# Five-Year Review Report

First Five-Year Review Report  
For  
Riverbank Army Ammunition Plant  
City of Riverbank  
Stanislaus County, California

**RE: Five-Year Review Report of Remedial Actions at Riverbank Army Ammunition Plant in Riverbank, California (Stanislaus County)**

## Final Addendum to the Five-Year Review Report for the Riverbank Army Ammunition Plant

FIGURE 1  
 SITE MAP OF DRAINAGE MDD.  
 RIVERBANK LANDFILL

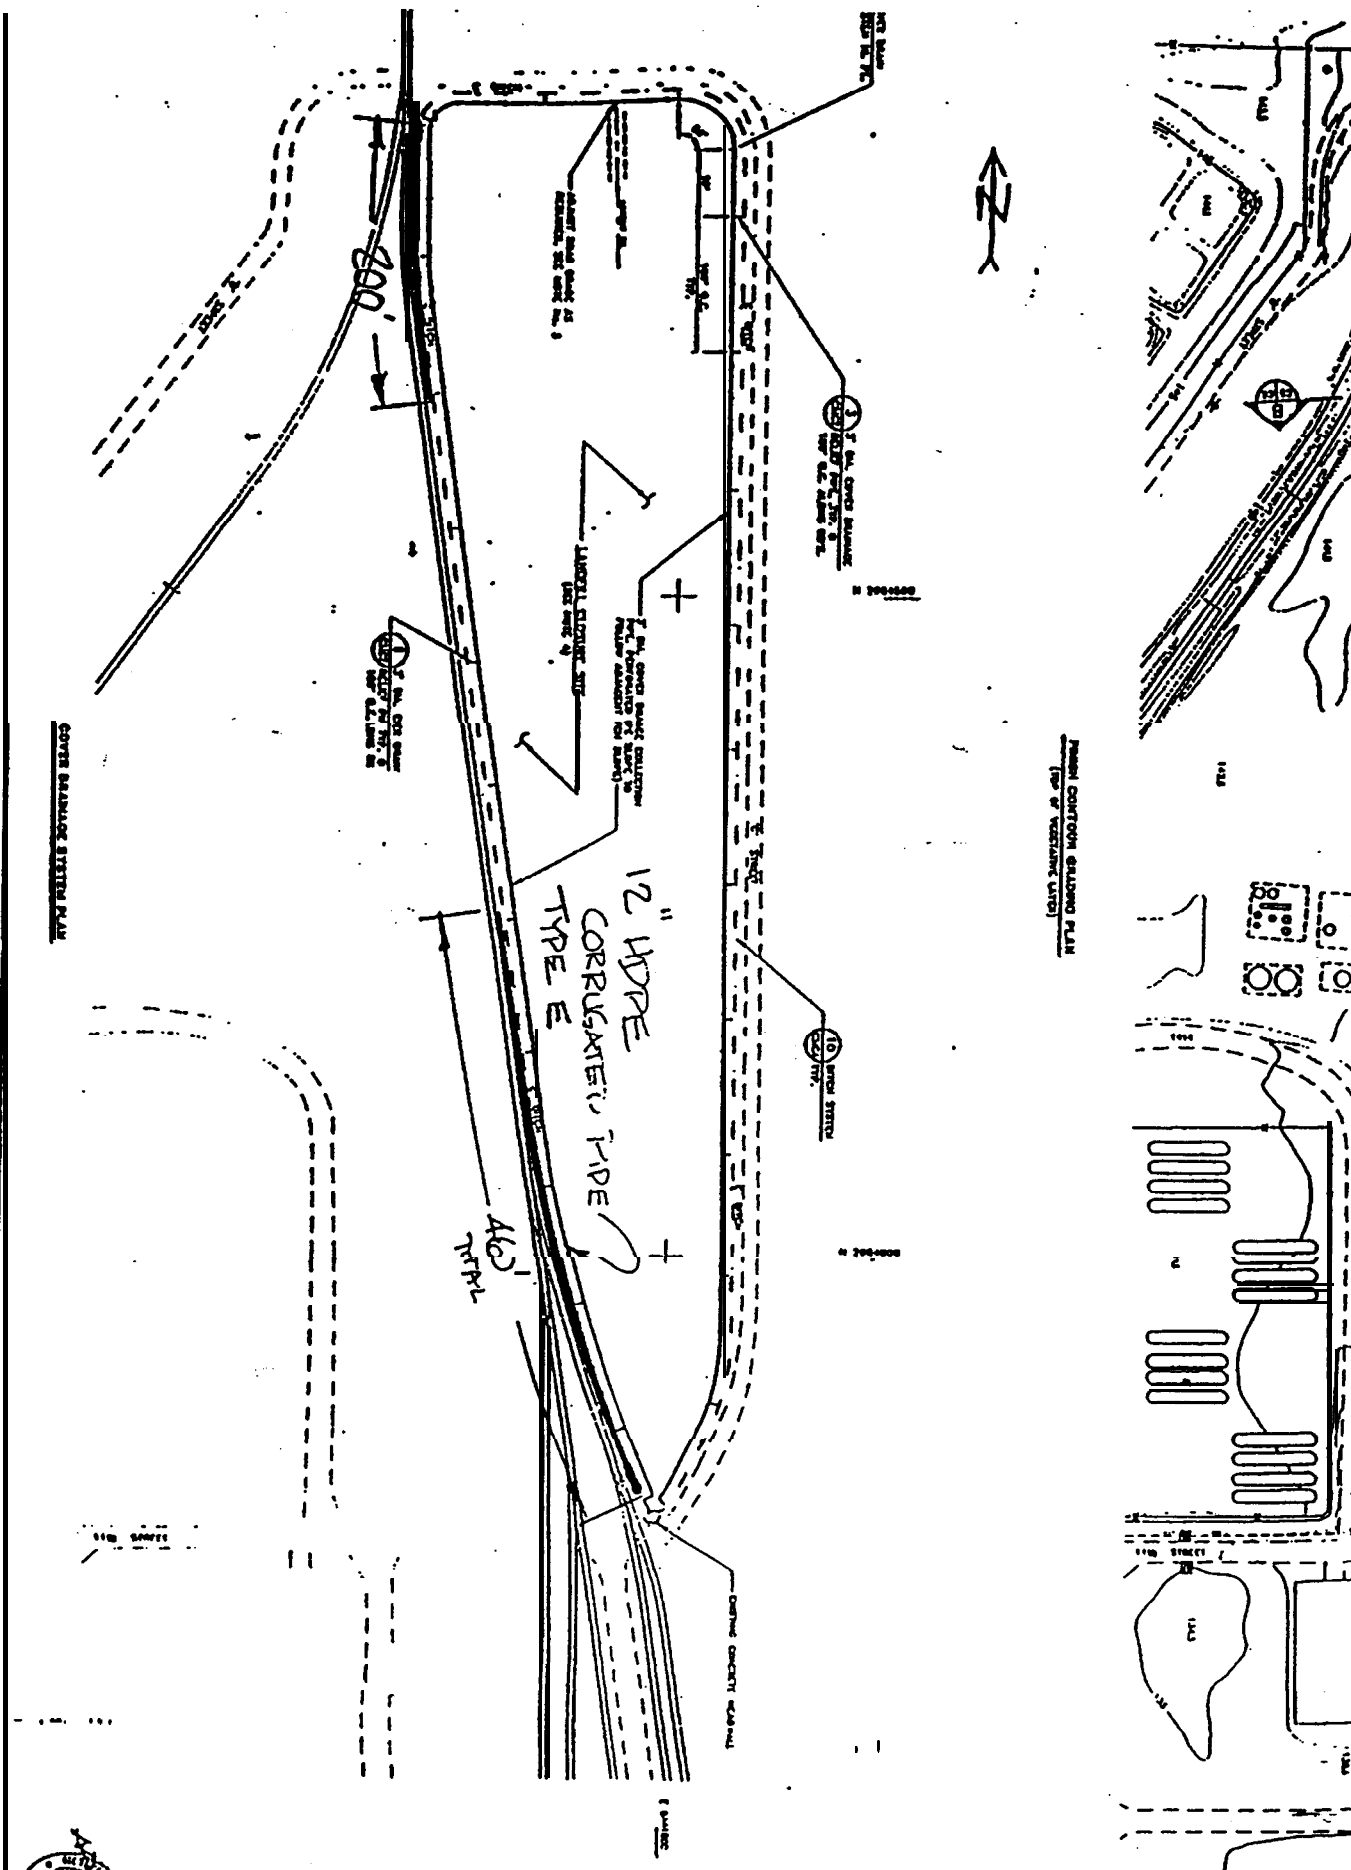
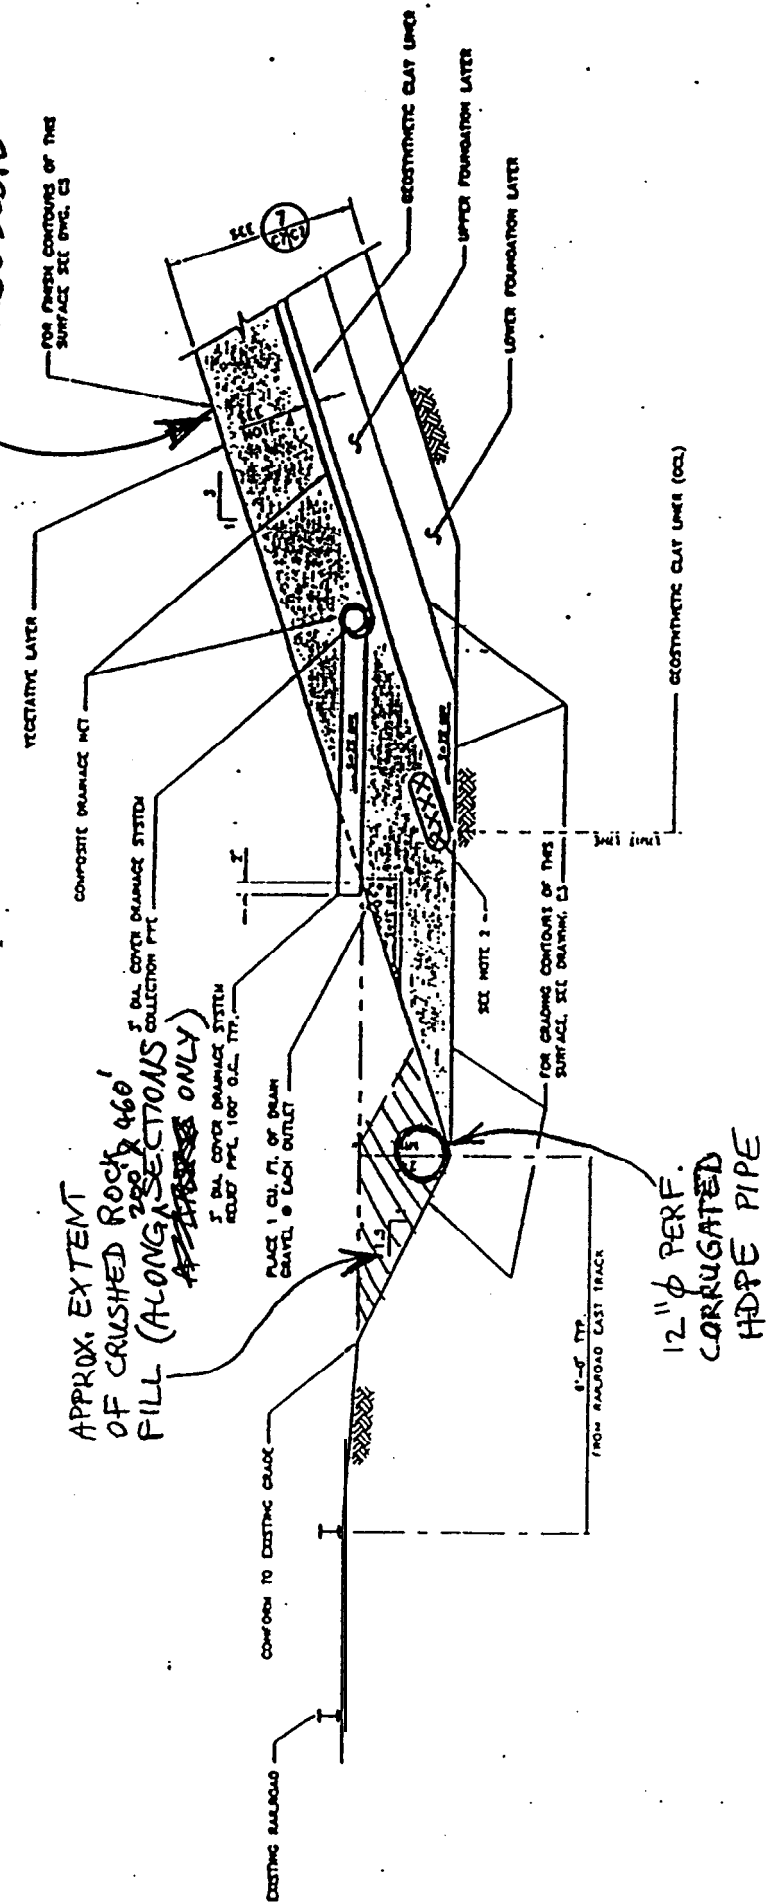
The approximate extent of vegetative cover damage is shown on Figure 1. The approximate extent of damage shown on this figure is not to scale, and field survey measurements should be performed to determine the exact aerial extent of vegetative cover damage. A typical section showing the perforated drainage pipe with approximate extent of additional crushed rock placed along portions of the toe of the western slope is shown on Figure 2. As indicated on this figure, the additional ballast material and drainage pipe result in a modification to the western landfill perimeter drainage system.

- Remove all remaining crushed rock, loose soil, and organic debris from the landfill cap surface.
- In areas where significant soft soil is present, carefully remove all soft soil and confirm that the CDN and/or GCL was not damaged.
- Re-compact additional soil as needed to fill in areas where soft soil has been removed.
- Repair all 3-inch-diameter subdrainage system relief pipes by replacing the crushed sections (i.e., removing crushed portions and splicing on new sections) and installing new rodent screens. Re-compact soil as needed around all repaired outlet pipes to restore the western slope to its original **3:1** grade.
- Replace gravel drain at each outlet (see Figure 2).
- Scarify and re-hydroseed all cap surface areas where vegetative cover has been removed and/or significantly damaged.
- Irrigate newly hydroseeded areas until a satisfactory stand of grass has taken root.

- Locate all drainage outlet pipes along the western side slope, including the five relief pipes that could not be readily located during our site visit.
- Provide adequate construction oversight to ensure that all repair work is adequately performed and that repair activities are appropriately recorded.
- Place additional crushed rock and/or an erosion mat upstream from the new **12-inch** perforated HDPE pipe and between the two perforated HDPE pipe sections, to reduce the potential for ditch erosion and excessive siltation of the pipe.

FIGURE 1  
TYP. DETAIL OF PERIMETER  
DRAINAGE MODIFICATION  
RBAAP LANDFILL

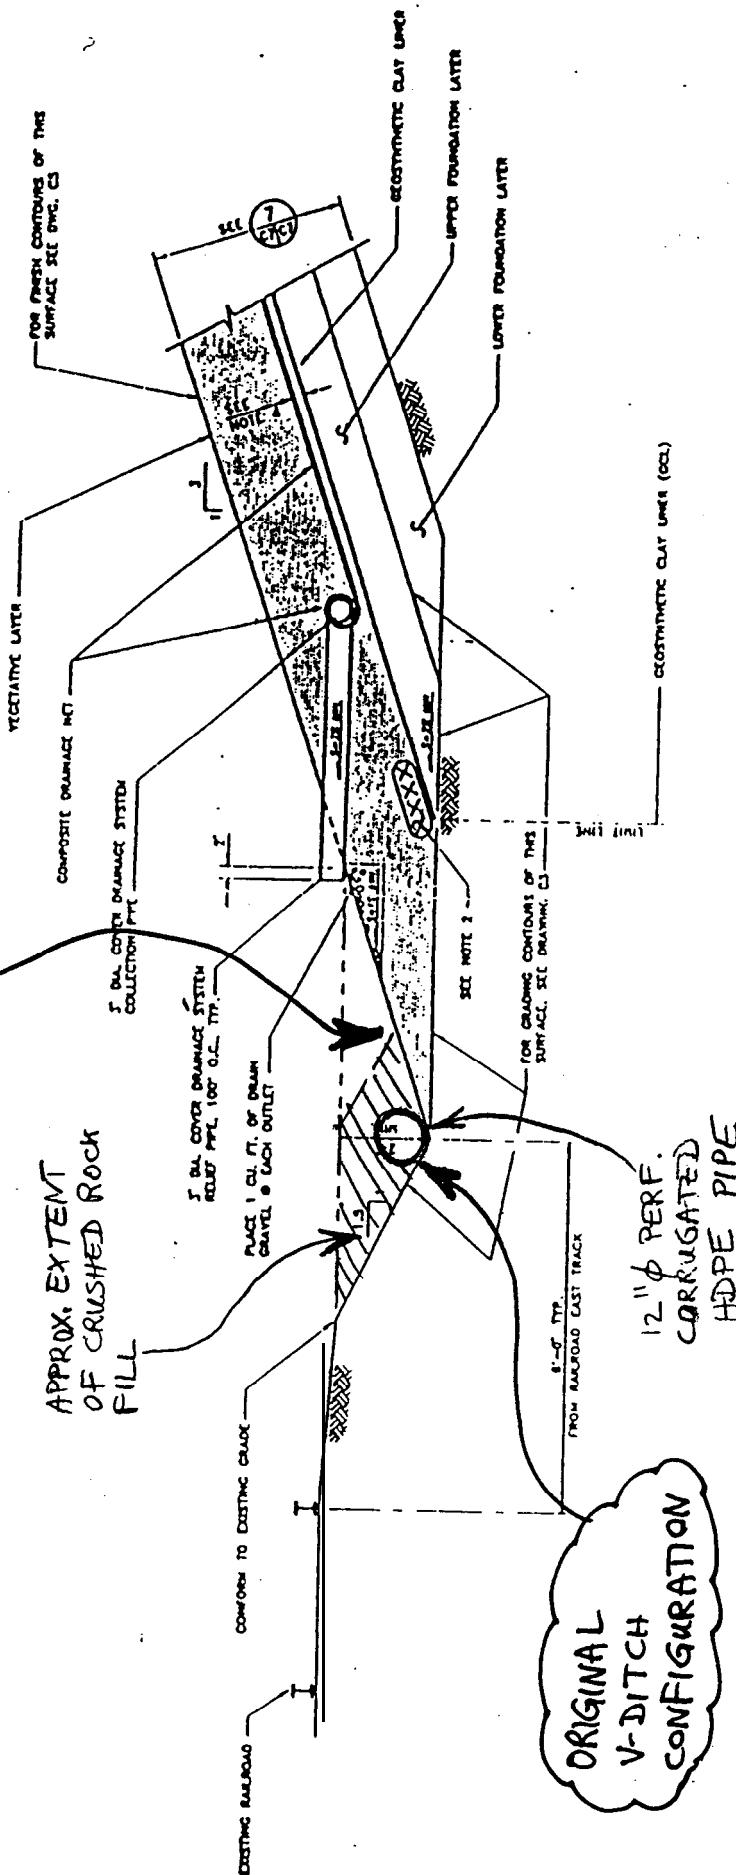
Based on the field observations discussed above, we recommend that all **3-inch** diameter subdrainage system relief pipes on the western slope be reconfigured to ensure that a 2 percent minimum slope is maintained between the lateral collection pipe and the relief pipe outlet inverts (see Figure 1).

FIGURE 2 : TYPICAL PROFILE ALONG NEW HDPE PIPE SEGMENTS (NTS)

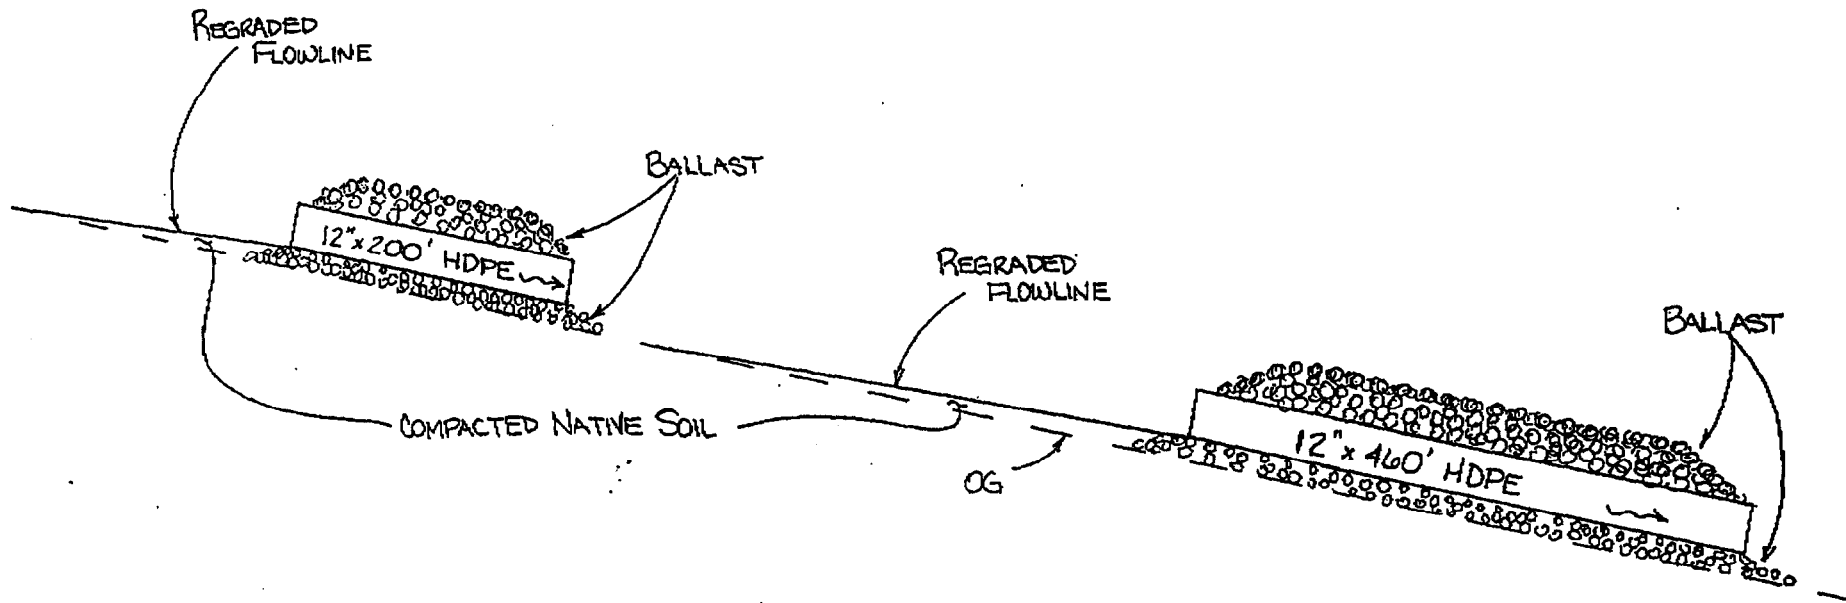
1. Leave the perforated pipe segments and crushed rock "as-is". Under this option, the crushed rock will likely clog over time causing the cover side slope sheet-flow runoff to be carried through the "new" ditch, adjacent to the pipe. Figure 1, attached, shows a cross-section of the landfill cap including the altered V-ditch. To reduce the potential for ponding upstream of the pipe inverts and water flow through the crushed rock under the pipe segments, we also recommend that the invert elevation of the V-ditch to the north of the 200-foot pipe segment be increased by about 4 to 6 inches (to be verified/adjusted in the field). Similarly, the grades of the V-ditch between the two pipe segments should be increased from approximately **4-6** inches at the invert of the **460-foot** section to zero at the outlet of the **200-foot** section. These proposed V-ditch invert grade adjustments are illustrated on the attached conceptual profile (Figure 2).

## Flowlines starting in the upgradient A/A' aquifer with MW104B pumping at 35 gpm and total pumping at 288 gpm

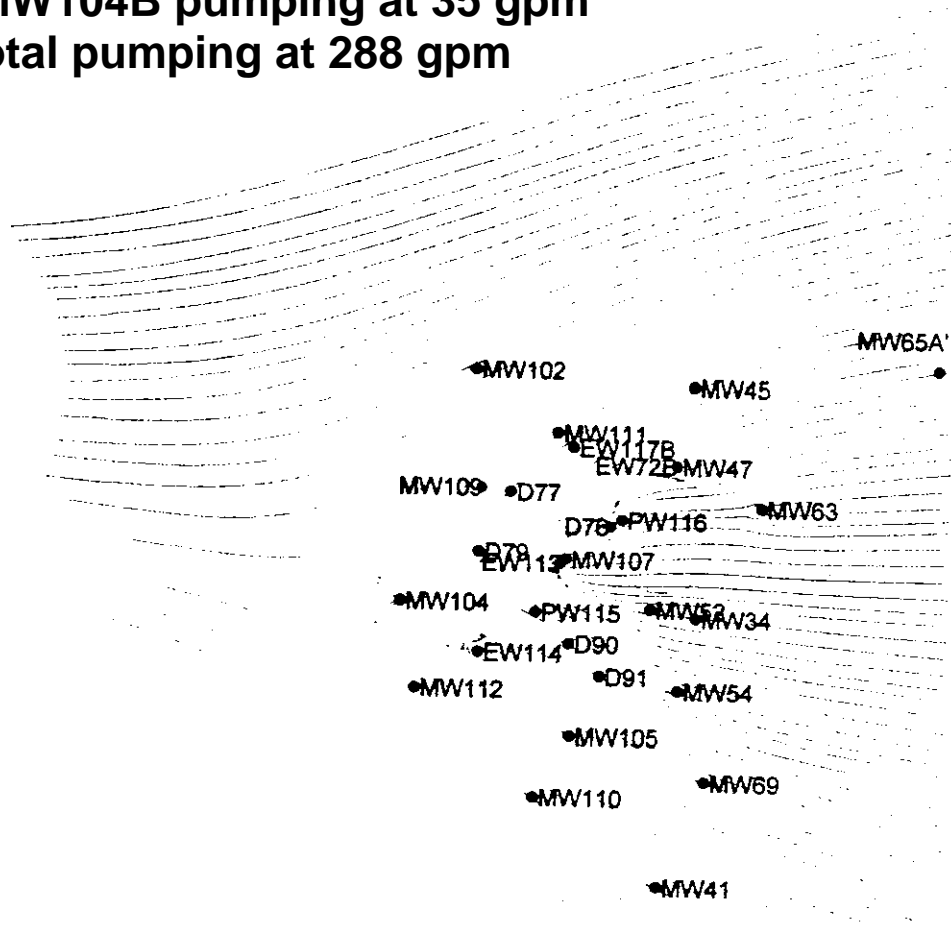
The current operating scenario (extraction at 172 gpm) for the groundwater extraction system does not create a capture zone large enough to contain water in the MW65A' area. MW65A' is considerably further north than any of the other current areas of contamination. The ROD requires full containment of all areas exceeding cleanup standards in the A'-, B-, and C-Zones. Although the Army acknowledges that this area of contamination would not be contained under the current operation scenario, extraction rates could be increased to provide capture of this area. Figure 1 (below) shows groundwater modeling simulation results prepared to demonstrate full capture at RBAAP at the time of the Construction Complete certification (September 1997). The location of MW65A' was added to the 1997 figure to illustrate that it falls well within the capture zone under the 288 gpm extraction scenario. Under the 288 gpm scenario, water from the MW65A' area eventually is captured at the off-base 113 extraction well cluster.

The Army is committed to complying with the ROD and providing full capture of all contamination in excess of cleanup standards in the A'-, B-, and C-Zones. There is plenty of time to continue to monitor conditions in the area before an increase in extraction is necessary to capture the MW65A' contamination. If conditions change, the Army will reassess the need for and timing of increased extraction rates. The types of changes that may warrant accelerating implementation of the modified extraction scenario include: concentration increases in MW65A' that result in levels in excess of 100 :g/L for several quarters in a row; concentration increases (into the 20 to 30 :g/L range) in downgradient monitoring wells that indicate a larger area of contamination than currently mapped; or changes in groundwater flow conditions that affect the orientation of the flow field. Each
